Access Compliance Report

Public Rights-of-Way

Intersection ID: 17680	Main Street: GREENWICH_RD	Cross Street: RANDOLPH_RD	Location: NE
ADA ID: 6526DBC41B83	Ramp Type: Perpendicular Diagonal	Initial Pass/Fail: Fail	Overall Compliance: No
		Severity Score: 12.5

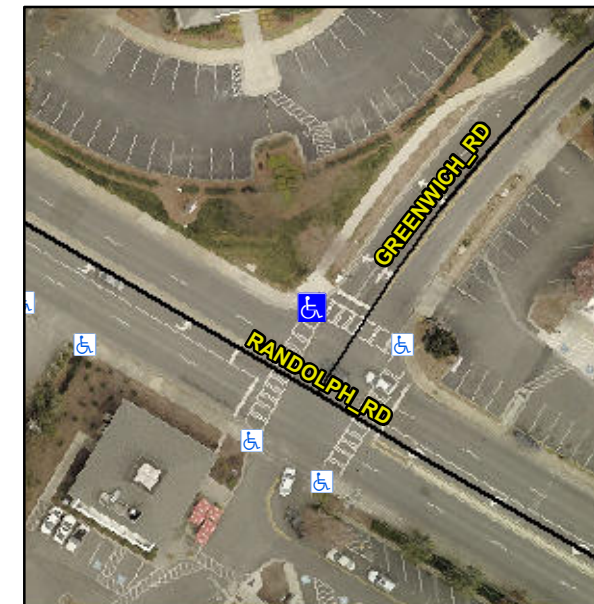
Compliance	Description	Data	Compliance	Description	Data
N/A	Ramp Length (in)	51.0	No	Ramp Slope (%)	10.7
Yes	Ramp Width (in)	72.0	Yes	Ramp XSlope (%)	0.4
N/A	Flare Type LT	N/A	N/A	Flare Type RT	N/A
N/A	Flare Slope LT (%)	N/A	N/A	Flare Slope RT (%)	N/A
N/A	Flare Traversable LT?	N/A	N/A	Flare Traversable RT?	N/A
N/A	Landing Length (in)	N/A	N/A	DWS Provided?	N/A
N/A	Landing Width (in)	N/A	N/A	DWS Contrast?	N/A
N/A	Landing Slope (%)	N/A	N/A	DWS Length (in)	N/A
N/A	Landing X Slope (%)	N/A	N/A	DWS Full Width?	N/A
N/A	Landing Curb? (Y/N)	N/A	N/A	DWS Offset (in)	N/A
N/A	Shared Landing?	N/A			
N/A	Gutter Ponding?	N/A	N/A	Gutter Slope (%)	N/A
N/A	Gutter Lip Ht (in)	N/A	N/A	Gutter X Slope (%)	N/A
N/A	Painted X Walk1?	Yes	N/A	Painted X Walk2?	Yes
	X Walk 1 Direction	To SW		X Walk 2 Direction	To SE
N/A	X Walk 1 Width (in)	106.0	N/A	X Walk 2 Width (in)	112.0
	X Walk 1 Slope (%)	4.5		X Walk 2 Slope (%)	3.3
	X Walk 1 X Slope (%)	3.2		X Walk 2 X Slope (%)	2.8

Remove & Replace Curb Ramp With Two New Directional Ramps or Equivalent.
